**Flood Control Project Maintenance
Levee Inspections**
LMA District Cover Sheet
Spring 2017 Levee Inspection Results

Sutter Maintenance Yard Maintenance Area 0003

Levee Inspection Report By Mile - Spring 2017

Waterway	Bank	Unit Miles	Inspection Start/End	Inspector
Unit No. 01 Feather River	Right	5.11	04/06/2017 04/06/2017	Sterling York

Photo 1 of 3 : UCIP_SP_2017_51481_64672.jpg

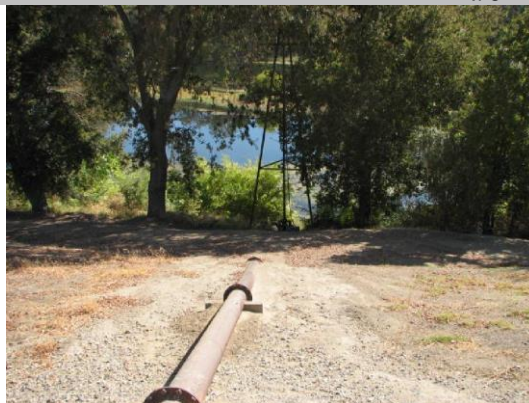
FS_ID:51481
DS_ID:17087
EP_NO: 1730
Repair Type: Non-Urgent
Crossing Status: Found
UCIP Comments: 4/11/2017 Big dig out/depression still present at the LS toe. Pipe is set to be replaced during the SBFCA project so depression should be repaired then. (DWR Sutter Yard - AFreitag)10/10/2016 Depression is still present at the LS toe but appears that it was dug out on purpose.(DWR Sutter Yard - afreitag)4/18/2016 Big depression on LS toe along the pipe alignment. 5/12/2015 Crossing appears to be in good condition. No noticeable issues to report.11/17/2014 Same as last inspection.5/14/2014 Same as last inspection.10/30/2013 Same as last inspection.5/21/2013 SBFCA project recommends replacing in accordance with title 23. Same as last inspection.
FIELD_STRUCT_DESC: 12-inch steel asphalt coated irrigation pipe through the levee, 4.5 feet below the crown. Gate valve and pump located on the waterside (WS). 24-inch concrete standpipe located on the landside (LS) toe has been degraded to ground elevation and filled in with soil. Pipe remains intact. Steel tower over pump is located on the WS. (Permit No. 1730, 1959 - Robert L. Crandall). [Additional Reference(s): DWR Levee Log, 2005].

Pipe, pump, and tower on WS slope/toe.
